OHIO TURNPIKE COMMISSION

ADDENDUM NO. 2

CONTRACT NO. 59-13-03
REPAIRS AND RESURFACING
EASTBOUND AND WESTBOUND ROADWAYS
MILEPOST 176.30 TO MILEPOST 186.02
SUMMIT AND PORTAGE, OHIO

CLARIFICATION TO ADDENDUM NO. 1 ON THE MODIFICATION TO THE DRAWINGS

| DATE : DECEMBER 2012 | SCALE: NONE |
|----------------------|----------------|
| CONTRACT : 59-13-03 | SHEET 7 OF 1.3 |

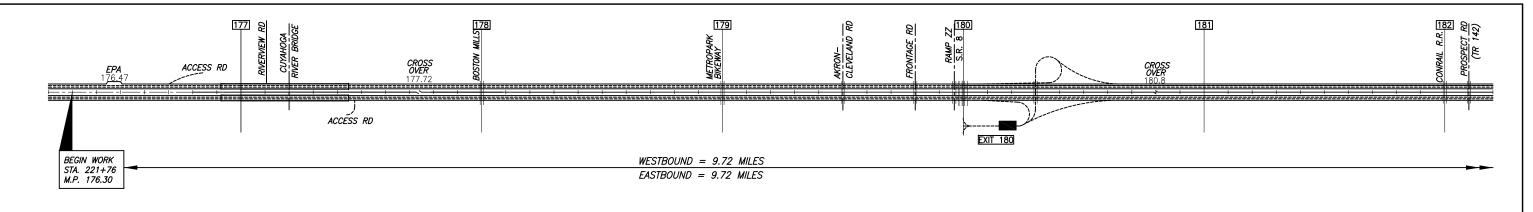
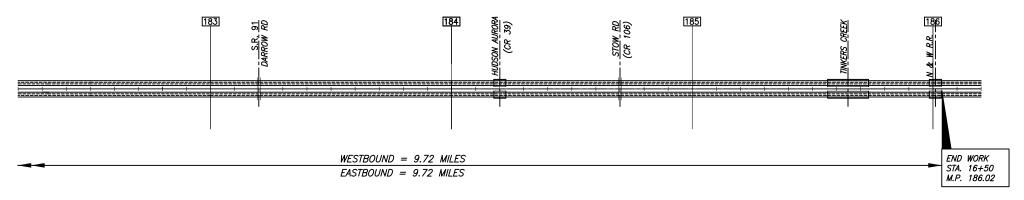
Clarification to Change one Plan Sheet 7 of 13

The replacement Plan Sheet 7 of 13 issued with Addendum No 1 correctly stated the limits for the four (4) foot wide SNAP Mill and Fill.

However, the explanation in Addendum No. 1 of the change to Plan Sheet 7 of 13 erroneously stated that the four (4) foot wide SNAP Mill and Fill is from Milepost 176.1 to Milepost 176.36 when the description should have specified that it terminated at Milepost 176.35.

Further, the excerpted new paragraph added to the General Note for "Item Special - 'SNAP' Mill and Fill" transposed Milepost numbers where the four (4) foot wide SNAP Mill and Fill commences at 176.1, not at Milepost 167.1 as previously stated in the description in Addendum No. 1.

Accordingly, the new paragraph excerpted in Addendum No. 1 that was added to the General Note for "Item Special - 'SNAP' Mill and Fill" on Plan Sheet 7 of 13 is modified to correctly restate the new paragraph as follows:

"FROM EASTBOUND MP 467.1 176.1 TO MP 176.35 ON THE LEFT SHOULDER, THE SNAP MILL AND FILL SHALL BE FOUR (4) FEET WIDE AND CENTERED TO INCLUDE THE REMOVAL OF EXISTING SNAPS, THE AREA BETWEEN THE YELLOW EDGE LINE AND THE EXISTING SNAPS, AND THE YELLOW EDGE LINE. OTHER THAN THE WIDTH, ALL REQUIREMENTS PREVIOUSLY SPECIFIED FOR SNAP MILL AND FILL SHALL APPLY TO THE FOUR (4) FOOT WIDE SECTION. THE ADDITIONAL WORK NECESSARY TO COMPLETE THE FOUR (4) FOOT WIDE SNAP MILL AND FILL ON THE LEFT SHOULDER FROM EASTBOUND MP 167.1 176.1 TO MP 176.35 SHALL BE CONSIDERED INCIDENTAL TO ITEM SPECIAL - "SNAP" MILL AND FILL, AND THE CONTRACTOR SHALL PLAN ITS OPERATION ACCORDINGLY. NO ADDITIONAL COMPENSATION SHALL BE GRANTED."

FROM EASTBOUND MP 176.1 TO MP 176.35 ON THE LEFT SHOULDER, THE SNAP MILL AND FILL SHALL BE FOUR (4) FEET WIDE AND CENTERED TO INCLUDE THE REMOVAL OF THE EXISTING SNAPs, THE AREA BETWEEN THE YELLOW FDGE LINE AND THE EXISTING SNAPS, AND THE YELLOW FDGE LINE. OTHER THAN THE WIDTH, ALL REQUIREMENTS PREVIOUSLY SPECIFIED FOR SNAP MILL AND FILL SHALL APPLY TO THE FOUR (4) FOOT WIDE SECTION. THE ADDITIONAL WORK NECESSARY TO COMPLETE THE FOUR (4) FOOT WIDE SNAP MILL AND FILL ON THE LEFT SHOULDER FROM EASTBOUND MP 176.1 TO MP 176.35 SHALL BE CONSIDERED INCIDENTAL TO ITEM SPECIAL — "SNAP" MILL AND FILL, AND THE CONTRACTOR SHALL PLAN ITS OPERATION ACCORDINGLY. NO ADDITIONAL COMPENSATION SHALL BE GRANTED.
